## SIB 52 08 21 RECALL 21V-521: CIS MAT

2021-10-15

This Service Information Bulletin (Revision 2) replaces SI B52 08 21 **dated August 2021**.

RE: Recall 21V-521: CIS Mat – B52 08 21

For section: Installing the seat cover for the front seat REP-TAT-P-5216-02-G01\_3

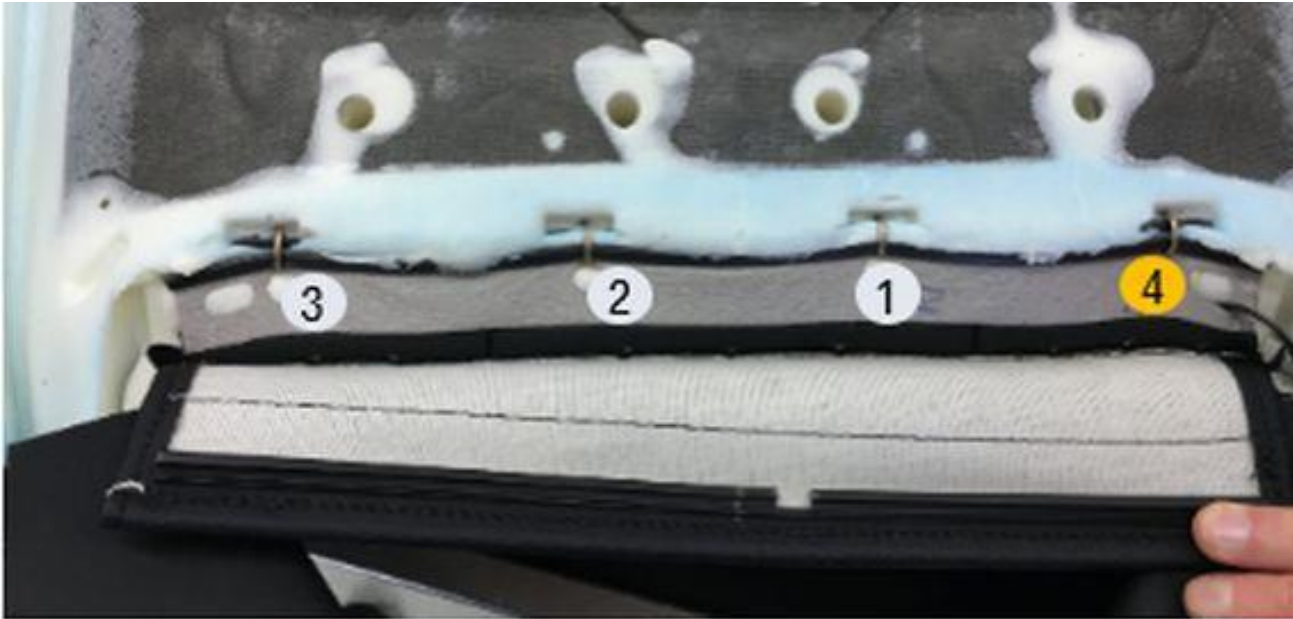
2. **Note: There is a changed procedure for clamping when installing the front seat cover- the new procedure below has not yet been incorporated into the repair instructions.**

**New:** The sequence in which the hog ring clamps are installed must be observed.

**First clamp items 1-3, then clamp the area of the cable outlet 4** to prevent the seat heater line from being contacted and/or damaged by clamps.
